CITY OF FREDERICKSBURG

PLANNING AND ZONING MEETING AGENDA WEDNESDAY, MAY 4, 2022 - 5:30 P.M. LAW ENFORCEMENT CENTER – 1601 E. MAIN STREET

DATE: May 4, 2022
TO: Planning and Zoning Commission
FROM: Shelby Collier, Associate Planner
SUBJECT: Z-2206 – Conditional Use Permit Application at 403 W. Austin St.

DATE: May 4, 2022
TO: Planning and Zoning Commission
FROM: Garret Bonn, Interim Development Services Director/Asst. City Engineer
SUBJECT: Consider a Multi-Family Development, Orchard Grove Phase II, Located at 1602 North State Highway 16.

CIVIL SITE PLAN FOR ORCHARD GROVE APARTMENTS - PHASE II
1602 STATE HIGHWAY 16 NORTH
FREDERICKSBURG, TX 78624

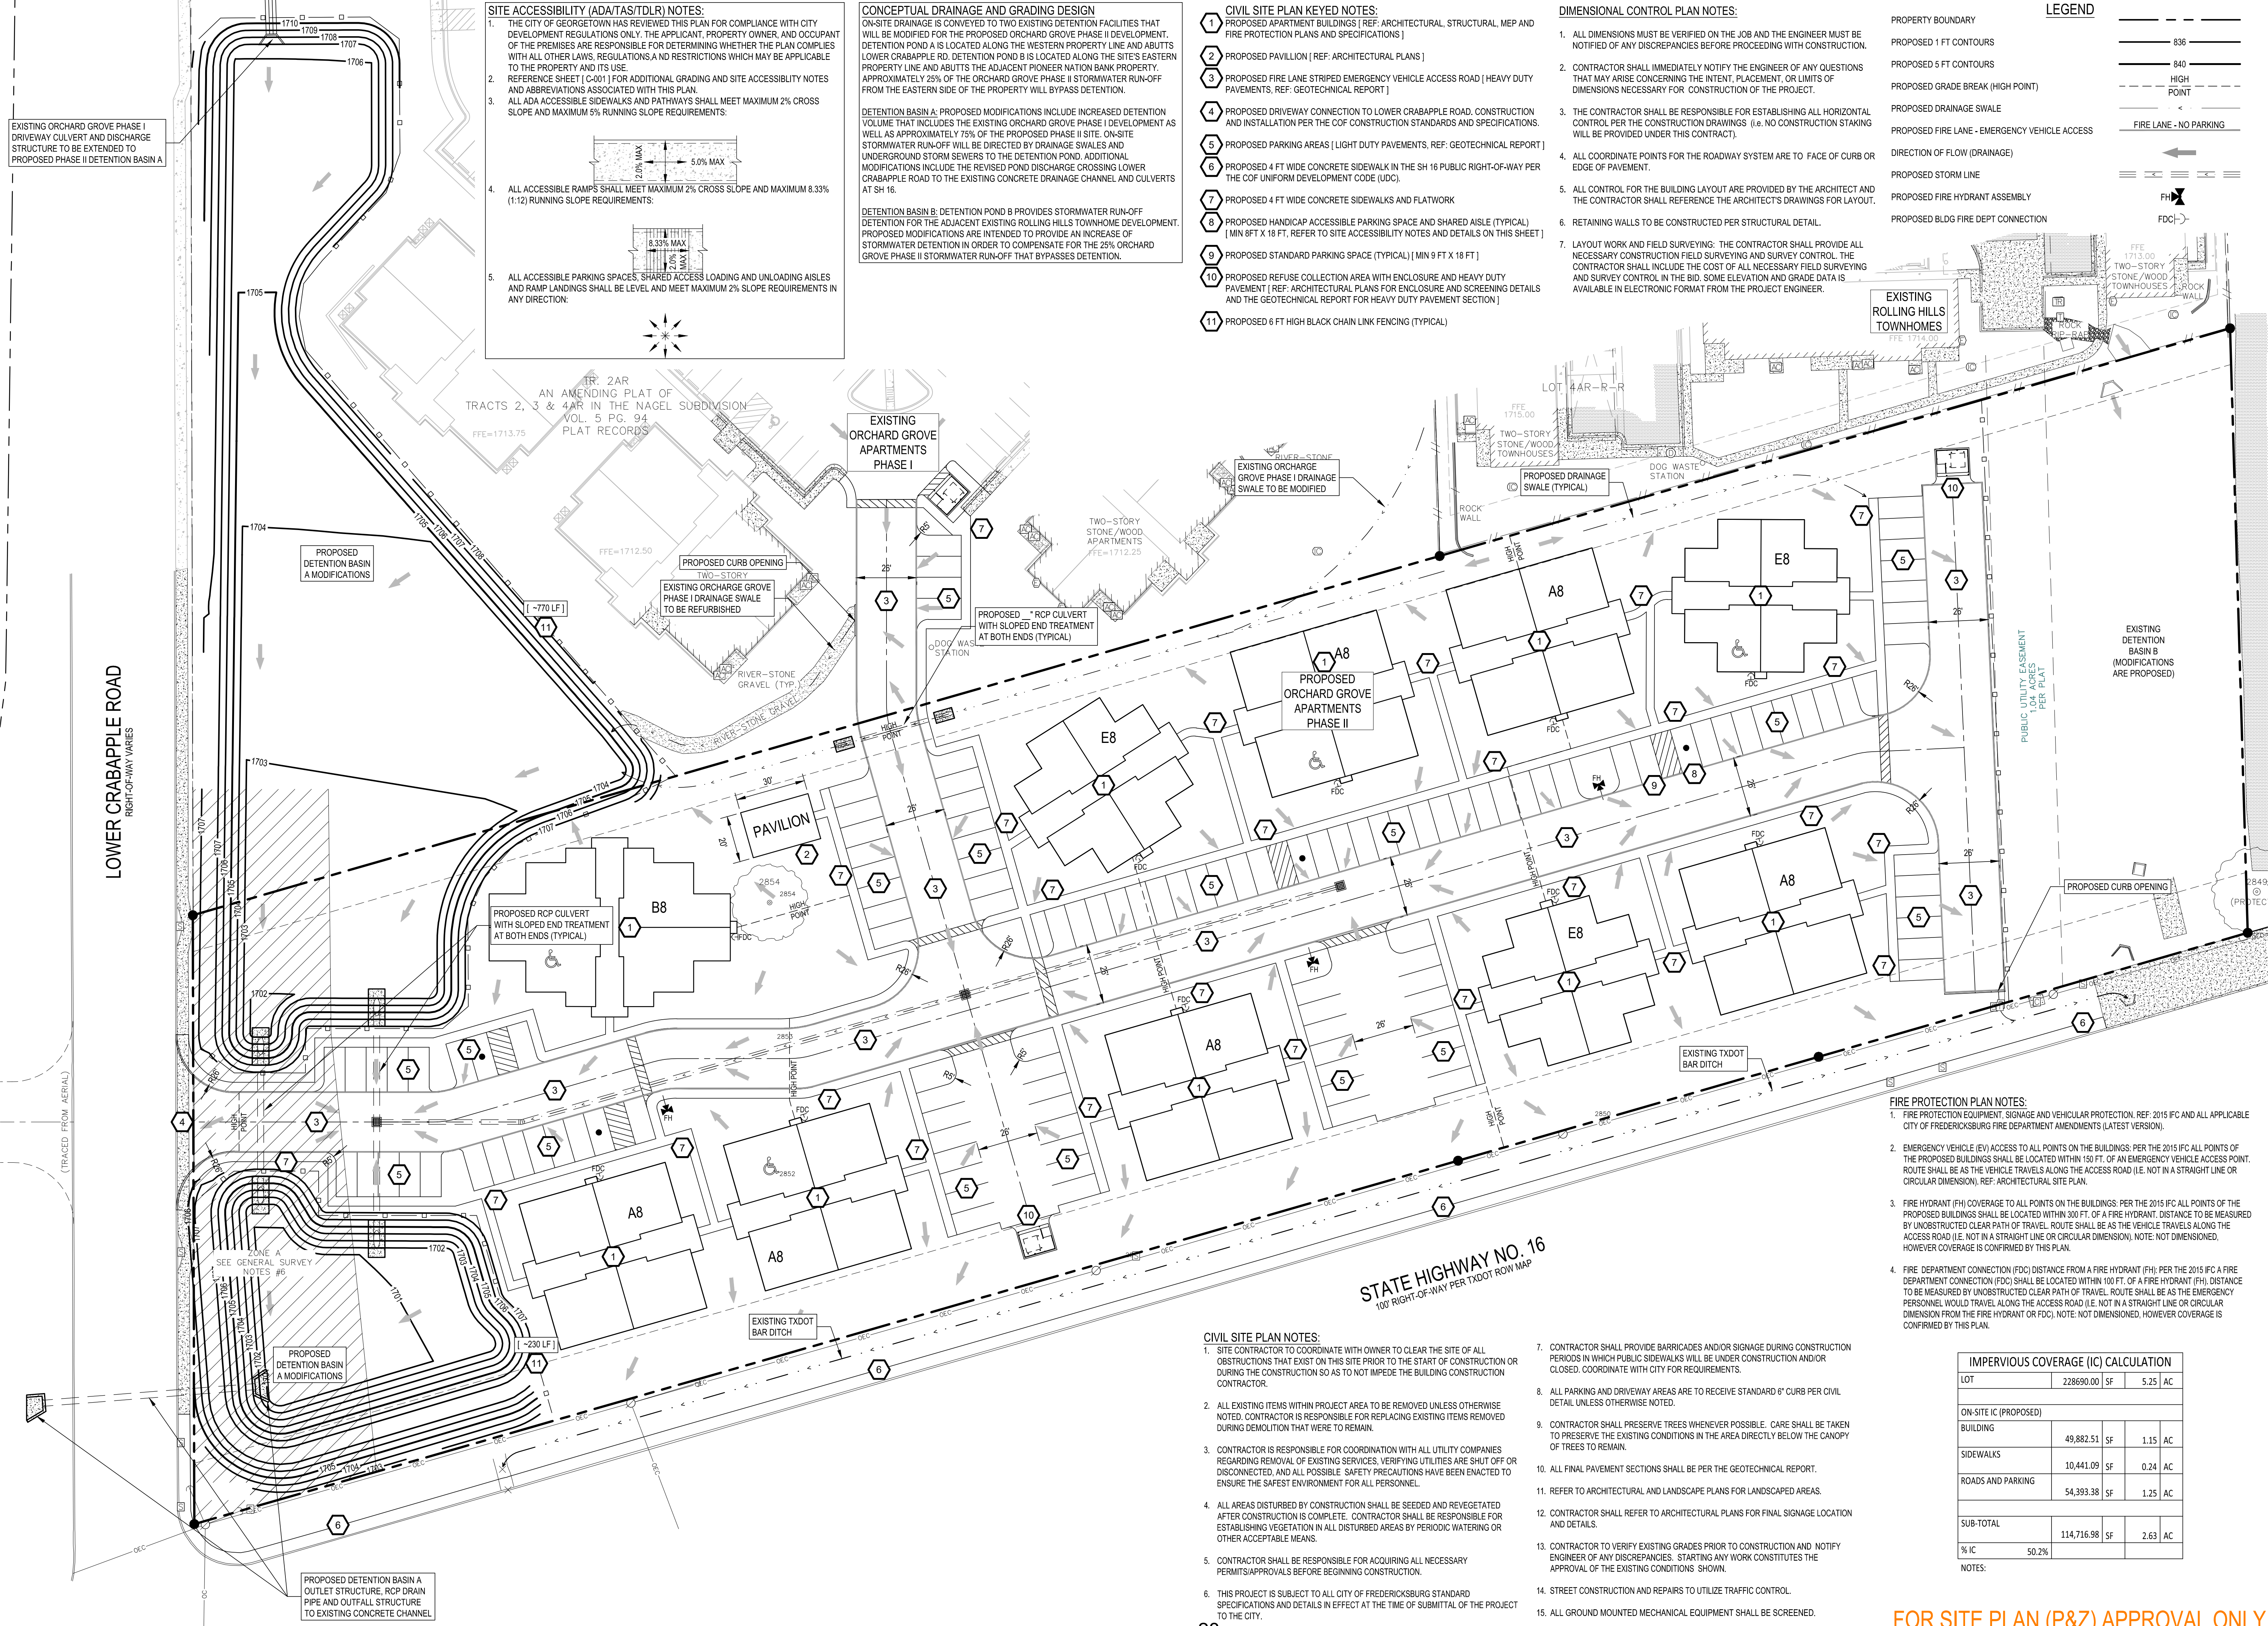
Comment 1:

In addition to site plan approval this project will require submission of civil construction plans to the Engineering Department for review. This review will include floodplain development permitting.

Comment 2:

Provide TXDOT approval for proposed improvements in TXDOT right of way.

Comment 1:

Please complete the Fire Department site plan review form which can be located at <https://www.fbgtx.org/DocumentCenter/View/4733/Fire-Department-Site-Plan-Checklist>

Comment 1: Site Plan requires Planning and Zoning Approval, Wednesday May 4th @ 5:30 PM.
Response: Noted.
Comment 2: Screening is required for solid waste containers.

Comment 3: Please provide interior floor plans to determine density.
Response: Noted. Interior floor plans shall be provided as part of the Building Permit Plans to be submitted to the CoF for approval and permitting.

Comment 4: Please provide Zoning Summary and include Density Calculations. Sec 3.210 Sec 7.600
Response: Noted. Zoning Summary and Density Calculations per Sec. 3.210 Sec. 7.600 shall be provided as part of the Building Permit Plans to be submitted to the CoF for approval and permitting.

Noted. Will provide. Civil Construction Plans and Floodplain Development Study shall be submitted to the City of Fredericksburg (CoF) for approval and permitting.

Noted. Will provide. TXDOT approval shall be provided as part of the Civil Construction Plans to be submitted to the CoF for approval and permitting.

Noted. Will provide. The Fire Department Site Plan Review Checklist (filled) shall be included as an Attachment to this Comments Response Letter. The Building Fire Suppression System and remote Fire Department Connections shall be provided as part of the Building Permit and Civil Construction Plans to be submitted to the CoF for approval and permitting.
<u>Development Services Comments</u>

Response: Noted. Screening shall be provided as part of the Building Permit and Civil Construction Plans to be submitted to the CoF for approval and permitting.

FIGURE 1
P-2206
Location Map
37

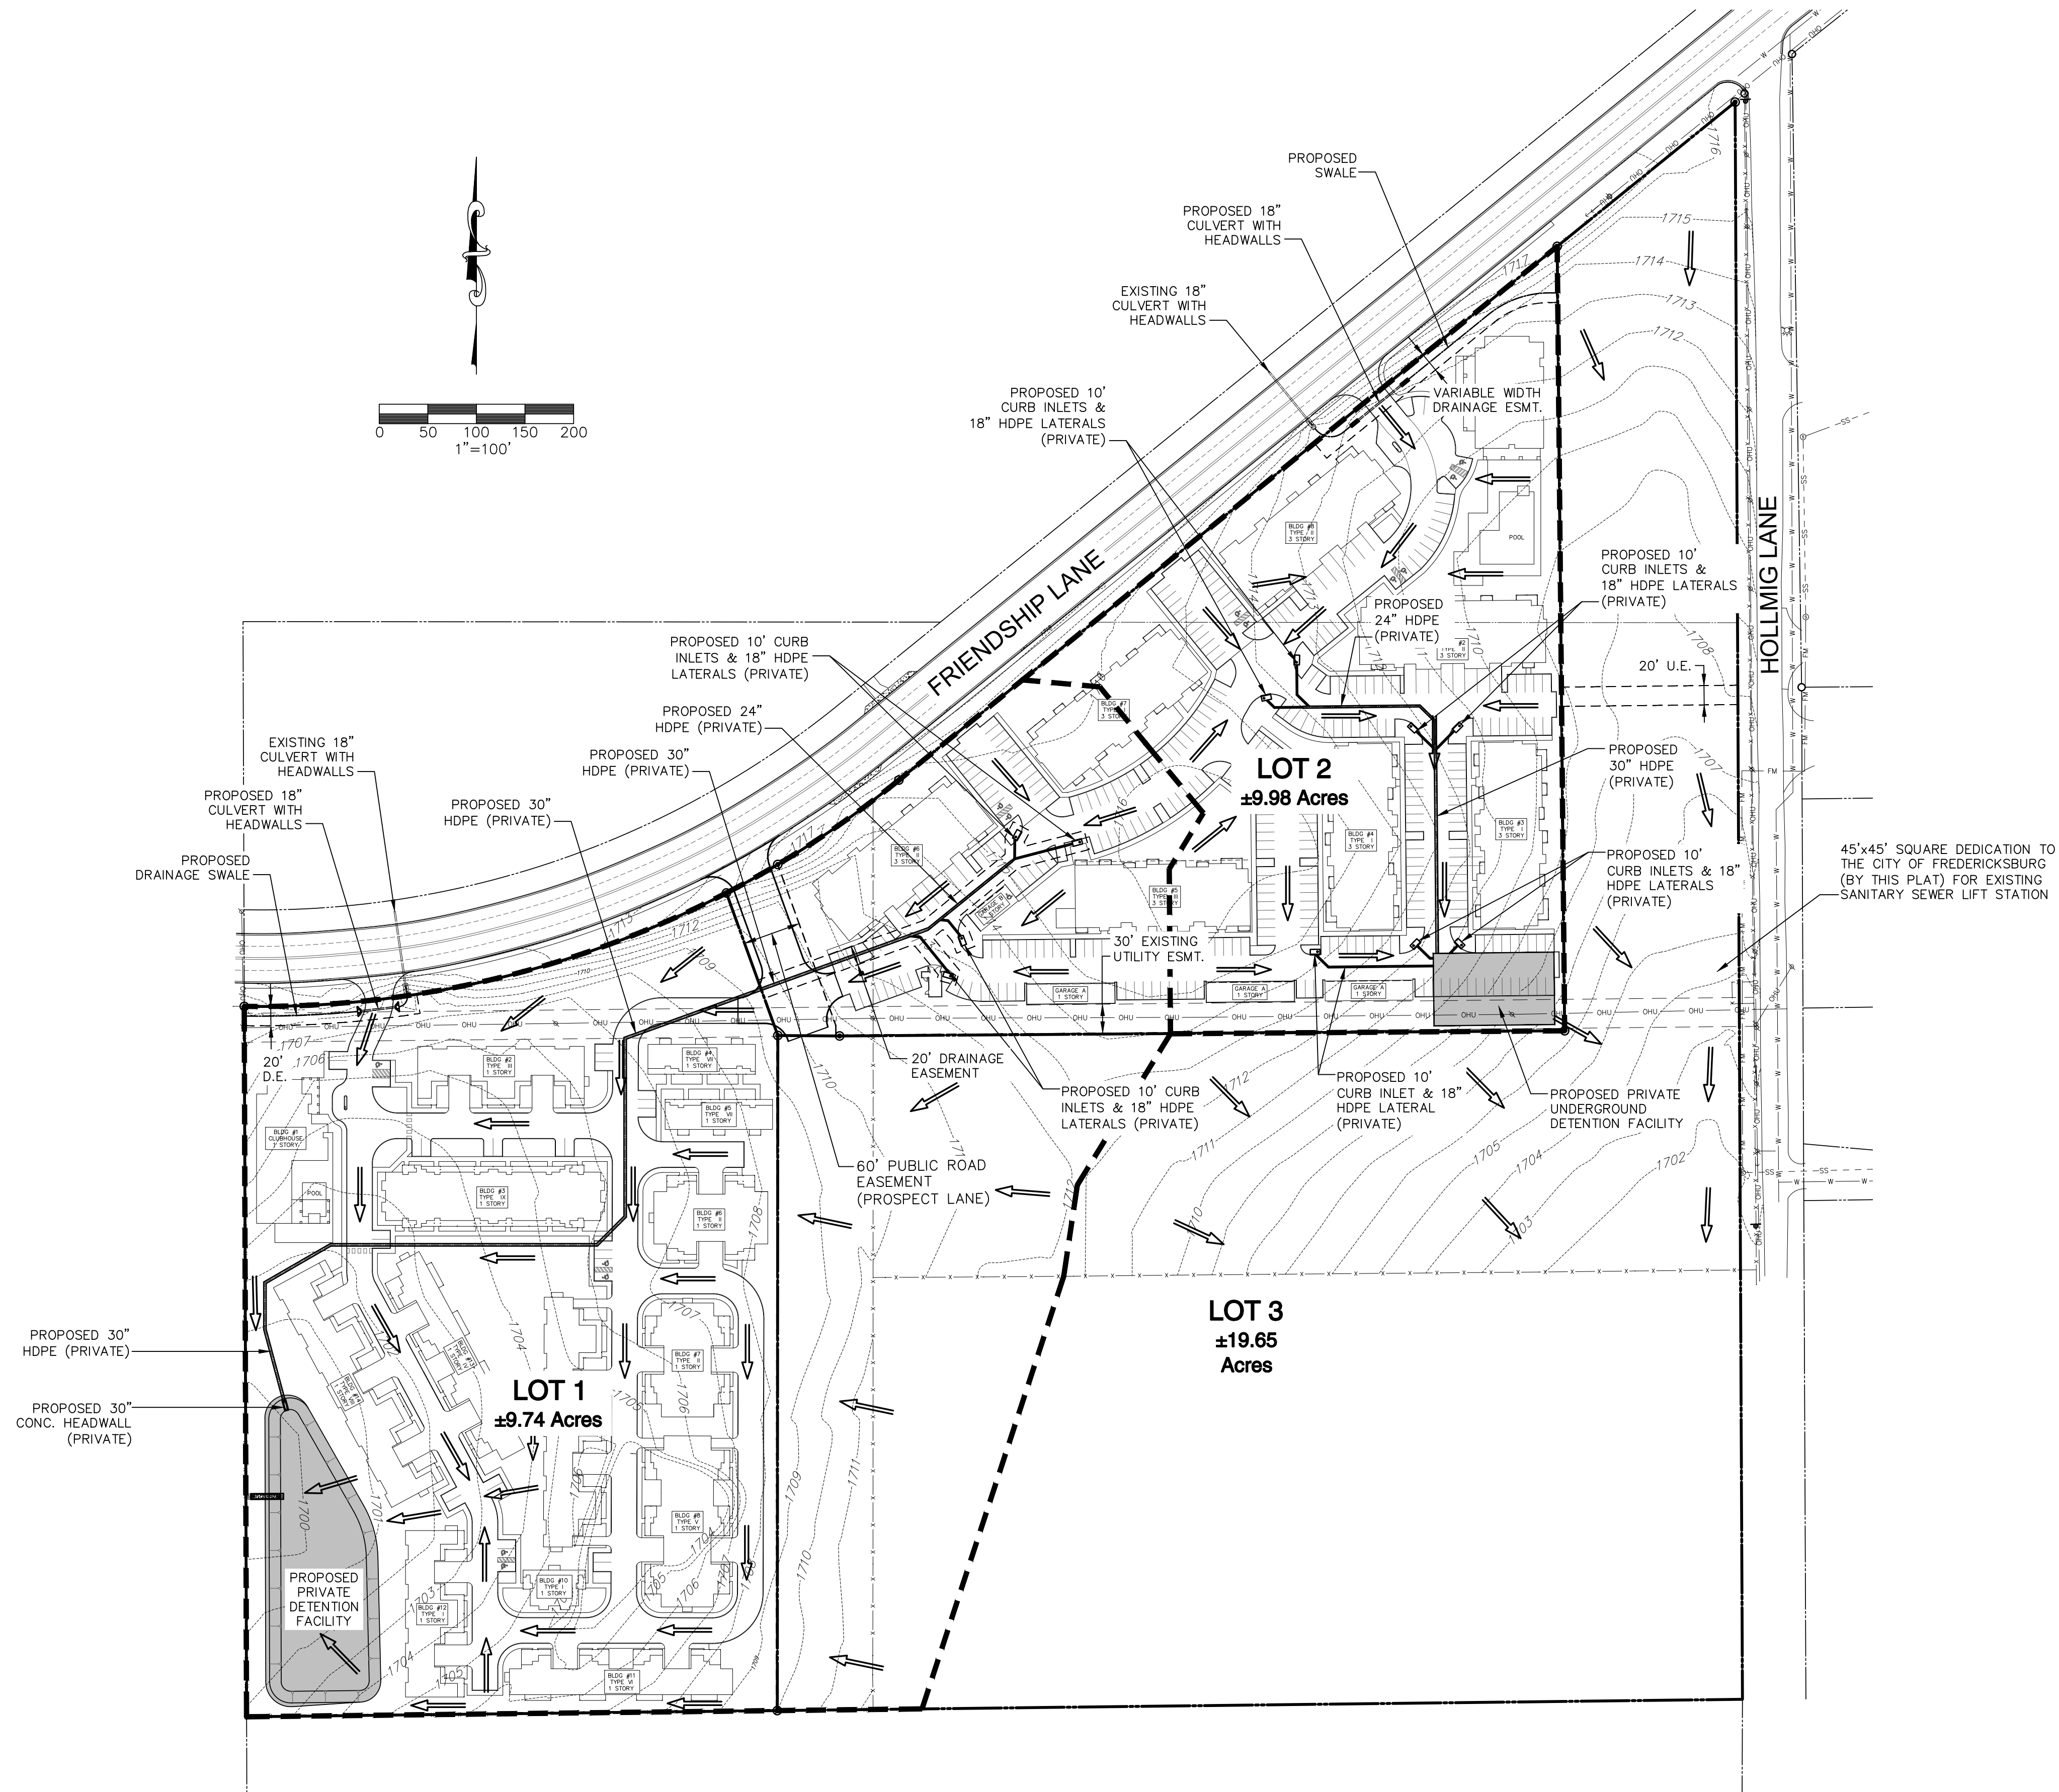
4. *In the comment response letter, it was stated the 20-foot utility easement on Lot 3 will no longer be dedicated by separate instrument. It is still noted by separate instrument. Please revise.*

5. *Show triangular site visibility easement at the corner of Friendship and Hollmig Lane.*

6. *Please add the sight visibility restriction note to the plat as written in the City's subdivision ordinance, Section 6.*

7. *Show right of way ties across Hollmig Lane.*

The call-out for the proposed 20-foot utility easement has been revised.

A sight visibility easement has been added at the corner of Friendship and Hollmig Lane.

The sight visibility restriction note has been revised as requested.

Right-of-way ties across Hollmig Lane have been added to the plat.
